# **e-STUDIO455SE and e-STUDIO855SE SERVICE MANUAL ADDENDUM**

Model: DP-2090/2520/3000/3570/4570  
DP-5550/6550/7550/8550  
Publish Date: November 2010  
File No. SME10002500  
R101121J7400-TTEC

#### 4-1. e-STUDIO455SE Series

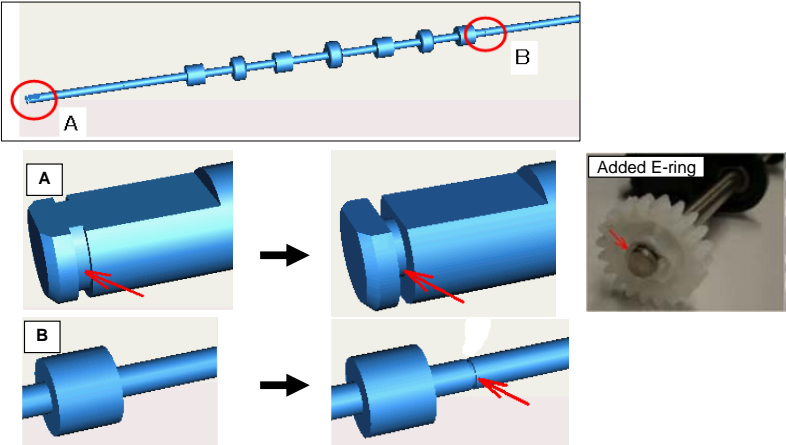
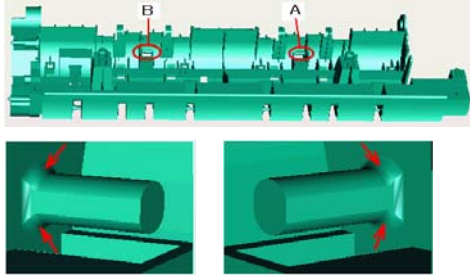
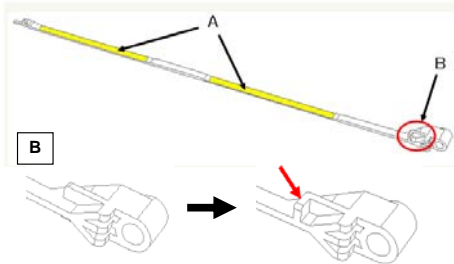
No.	Items	Parts
S/W	-	0	System Software: T470SY0U230 The Data Overwrite Enabler (GP-1070) and the External Interface Enabler (GS-1020) are equipped as standard features so as to enhance security.	-
H/W	Paper Exit Section	1	The cover is reshaped to improve serviceability.	COVER-EXIT-AC1050
			A reinforcing rib is added. Chamfering is applied to improve serviceability.	GUIDE-EXIT-L-473
		2	The offset gate guide (slide guide) are reinforced.	GUIDE-SLIDE-473 BRKT-EXIT-LOW
		3	Dislocation of the bushing is prevented.	BUSH-F6-GCB
		4	Dislocation of the gear is prevented.	GEAR-10S20-06
	Reverse Section	5	The part in the Reverse Section is stronger	GUIDE-EXIT-UPR-L-473
	ADU	6	The thickness of the stopper is changed from 0.69 mm to 1.0 mm.	STOPPER-ADU-47X-S
	Fuser Unit	7	The protrusion is reinforced.	-
	Cover	8	The front cover is improved not to be opened during copying.	COVER-FRONT-L-N SPL-COV-LOCK
	Paper Feeding Section	9	Coming off the pickup roller is prevented.	ARM-RLR-PICK-F47X-F ARM-RLR-PICK-F47X-R

10	Wearing out the pusher of the registration roller is prevented.	PUSH-RGST-470-V
	Others (Image / Noise)	11	Black streaks on images are suppressed.	ASYB-PWA-LGC-470S ASYB-PWA-LGC-471S ASYB-PWA-LGC-472S ASYB-PWA-LGC-473S ASYB-PWA-LGC-474S
		12	The driving noise of the main motor is reduced.	GEAR-5H58_4H48-6 GEAR-4H118_PS2M38-6_H
		13	Acoustic noise and image deviation are suppressed.	ASYS-BRKT-TENS-47X
		14	Electrical conduction of the exit roller is improved.	SPL-T-EARTH-EXIT-471 SPL-T-EARTH-EXIT-473
Overview (Cover)	15	The emblem is changed.	SHEET-EMBLEM-*****

#### 4-2. e-STUDIO855SE Series

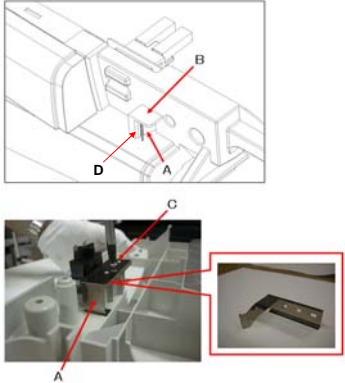
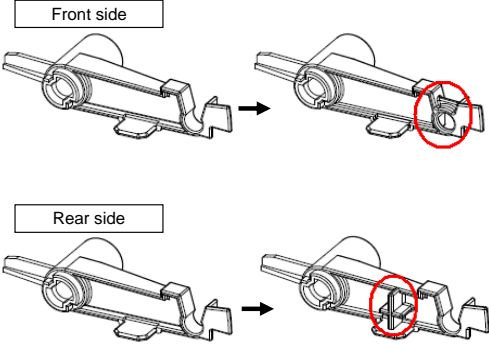
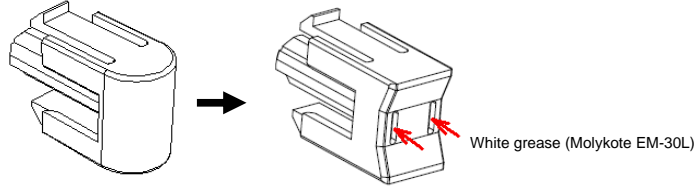
No.	Item	Parts
S/W	-	0	System Software: T100SY0U230 The Data Overwrite Enabler (GP-1070) and the External Interface Enabler (GS-1020) are equipped as standard features so as to enhance security.	-
H/W	Overview (Cover)	15	The emblem is changed.	SHEET-EMBLEM-*****

5. Details

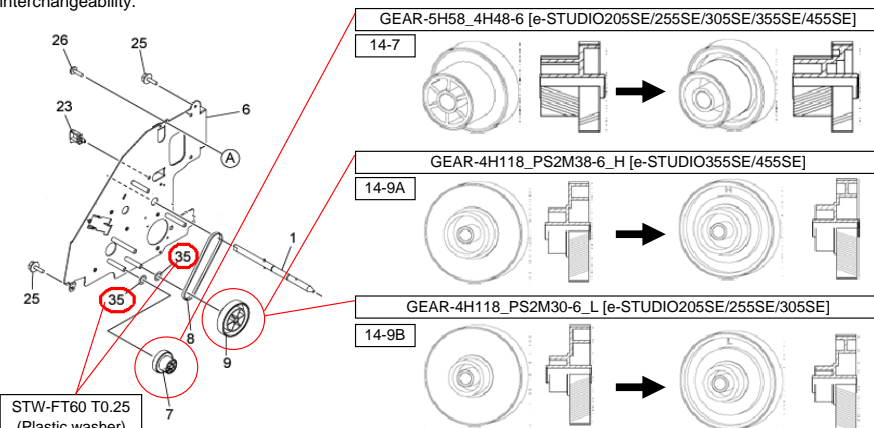
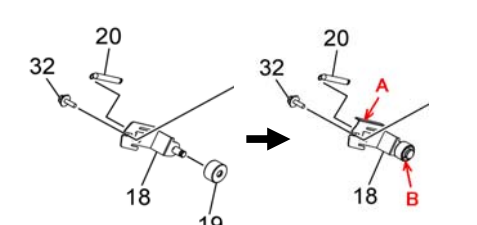
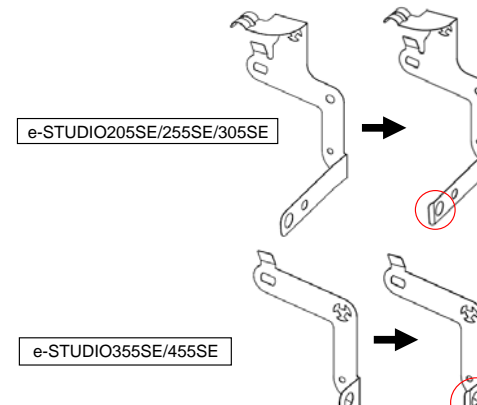
No.	Unit	Parts	Contents
1	Paper exit section	GUIDE-EXIT-L-473 COVER-EXIT-AC1050 [e-STUDIO355SE/455SE]	<p>To improve the serviceability when the reverse unit is disassembled, the shape of its cover has been changed to avoid interference, and the guide of the exit unit is reinforced.</p> <p>1. Cover of the reverse unit (Notch added)</p>  <p>2. Guide of the exit unit reinforced (Shape of the rib changed, C chamfer added)</p>  <p>A: Padding applied to the rib B: Chamfering applied</p>
2	Paper exit section	GUIDE-SLIDE-473 BRKT-EXIT-LOW [e-STUDIO355SE/455SE]	<p>The thickness of the reinforcing plate has been changed from 0.8 mm to 1.0 mm to avoid warpage of the offset gate (slide) guide which would cause paper jamming. A fixing hole has been added to its center. The fixing screws have been changed to stepped screws, as well as having their quantity increased from 2 to 3.</p> 
3	Paper exit section	BUSH-F6-GCB [e-STUDIO355SE/455SE]	<p>To prevent the bushings from coming off the mold frame, the depth of those for the reverse roller and the upper transport roller has been changed from 6 mm to 9 mm. (2 points on the front side)</p>

No.	Unit	Parts	Contents
4	Paper exit section	ROL-EXIT-473 [e-STUDIO355SE/455SE]	<p>To avoid a CDF0 error caused by the exit roller gear dropping from the shaft, the diameter of the gear-fixing groove in the exit roller shaft section has been changed from 5 mm to 4 mm, and also an E-ring has been added [Figure A]. To distinguish the new shaft and the old one, a groove has been added to the new one [Figure B].</p> 
5	Reverse section	GUIDE-EXIT-UPR-L-473 [e-STUDIO355SE/455SE]	<p>To prevent damage to the bosses holding the springs for pressing the roller in the reverse unit, the following changes have been applied. If these bosses are damaged, image skewing and paper jamming in the paper exit section can occur.</p> <ul style="list-style-type: none"> <li>- Their base shape has been changed to improve their strength.</li> <li>- Their material has been changed to increase their resilience and heat resistance.</li> <li>- Their color has been changed from white to black for identification.</li> </ul>

6	ADU	STOPPER-ADU-47X-S	<p>To prevent damage to the fixing band in the ADU by maintenance work in the field, the thickness of sections A below (shown in yellow) has been changed from 0.65 mm to 1 mm to reinforce the band. Also the shape of section B below has been changed to distinguish the new band and the old one.</p> 
7	Fuser unit	[e-STUDIO205SE/255SE/305SE/355SE/455SE]	<p>A roundness of 0.5 has been applied to the protrusion of the fuser unit to improve its strength.</p>

No.	Unit	Parts	Contents
8	Front cover	COVER-FRONT-L-N SPL-COV-LOCK  [e- STUDIO205SE/255SE/305S E/355SE/455SE]	<p>A plate spring has been added to reinforce the fixing section of the front cover. Also a rib has been added to the left front cover to stop the edge of the plate spring contacting other parts.</p> <p>A: New plate spring B: Rib added to the left front cover C: Secure the plate spring together with the bracket. D: White grease (Molykote EM-30L)</p> 
9	Paper feeding section	ARM-RLR-PICK-F47X-F ARM-RLR-PICK-F47X-R  [e- STUDIO205SE/255SE/305S E/355SE/455SE]	<p>When the drawer feeding unit is installed or removed, the pickup roller may come off from the pickup arm if its rubber section is pushed. (Only for the front one) To avoid this, the shape of the pickup arm has been changed. The same arm was used for both the front and rear sides in existing models; however, a different arm will be employed from this model.</p>

10	Paper feeding section	PUSH-RGST-470-V  [e- STUDIO205SE/255SE/305S E/355SE/455SE]	<p>The shape of the pusher for the rubber registration roller has been changed to prevent it from wearing out. When replacing the pusher in the field, apply a blob of White grease (Molykote EM-30L; the size of two grains of rice) onto each contact section between it and the roller shaft.</p> 
11	Others (Image / Noise)	ASYB-PWA-LGC-470S ASYB-PWA-LGC-471S ASYB-PWA-LGC-472S ASYB-PWA-LGC-473S ASYB-PWA-LGC-474S  [e- STUDIO205SE/255SE/305S E/355SE/455SE]	<p>Black streaks in a primary scanning direction (at a right angle to the paper feeding direction) appeared on images due to electrostatic noise. To increase the tolerance level to electrostatic noise, the resistance value (R50) was changed and a capacitor (C55) was added.</p>  <p>R50: 22 ohm -&gt; 1k ohm C55: - -&gt; 33 picofarad</p>

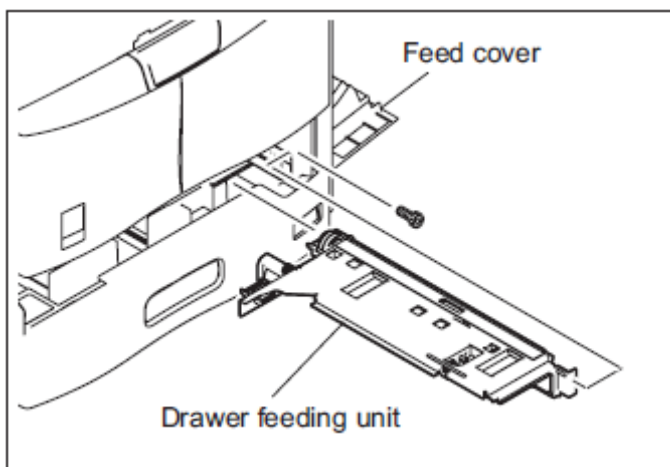
No.	Unit	Parts	Contents
12	Paper feeding section	<p>GEAR-5H58_4H48-6 GEAR-4H118_PS2M38-6_H STW-FT60 T0.25 [e-STUDIO355SE/455SE]</p> <p>GEAR-5H58_4H48-6 GEAR-4H118_PS2M30-6_L STW-FT60 T0.25 [e-STUDIO205SE/255SE/305SE]</p>	<p>To reduce noise occurring when the main motor is stopped, its driving gears have been changed and the plastic washers have been added. Also the angle of the teeth of the gear has been changed to prevent the gear from being moved to its loose side. To avoid leaning in the rattling direction, the helical direction of the helical gear will be changed. (See the figures) The shape will be also altered to make it distinguishable. When changing the current gears (14-7, 14-9) to the new ones, exchange them in a set since there is no individual part interchangeability.</p>  <p>STW-FT60 T0.25 (Plastic washer)</p>
13	Paper feeding section	<p>ASYS-BRKT-TENS-47X [e-STUDIO205SE/255SE/305SE/355SE/455SE]</p>	<p>The tension roller in the main motor drive unit rarely comes off due to deformation of the bracket (metal plate). This may cause abnormal noise and image leading edge deviation. To avoid this, the following changes in the tension bracket have been applied.</p> <p>A: A bend has been added to strengthen the bracket (metal plate). B: The tension roller has been integrated into the unit so that it does not come off.</p>

14	Paper feeding section	<p>SPL-T-EARTH-EXIT-471 SPL-T-EARTH-EXIT-473 [e-STUDIO205SE/255SE/305SE/355SE/455SE]</p>	<p>The shape and the material of the plate spring have been changed to improve electrical conduction between the exit roller and the frame on the equipment. (Material: SUS304 -&gt; SUS631)</p>  <p>e-STUDIO205SE/255SE/305SE</p> <p>e-STUDIO355SE/455SE</p>

### 6-1. Pickup roller

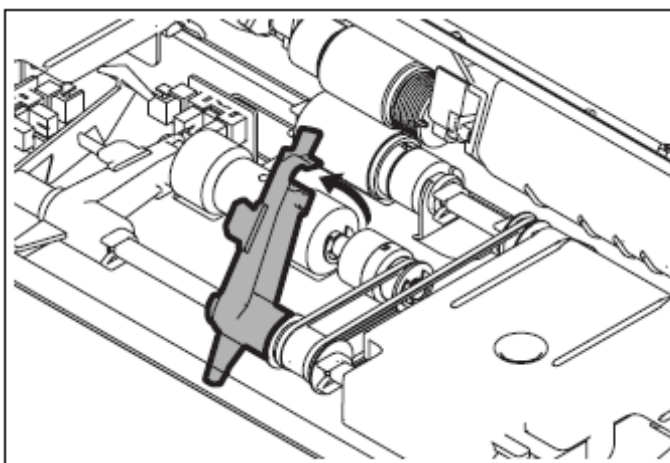
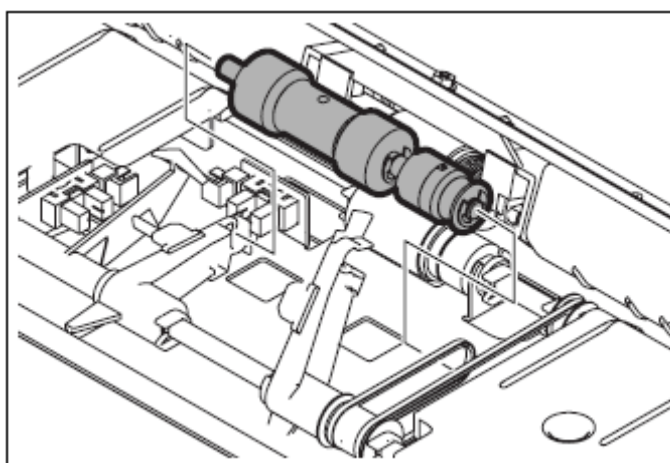
The disassembly procedure changes by the change in the picking up arm (item #9).

(1) Remove 1 screw and take off the drawer feeding unit by sliding it to the front side.

(2) Pull up the rear side pickup arm.

(3) Take off the pickup roller assembly.
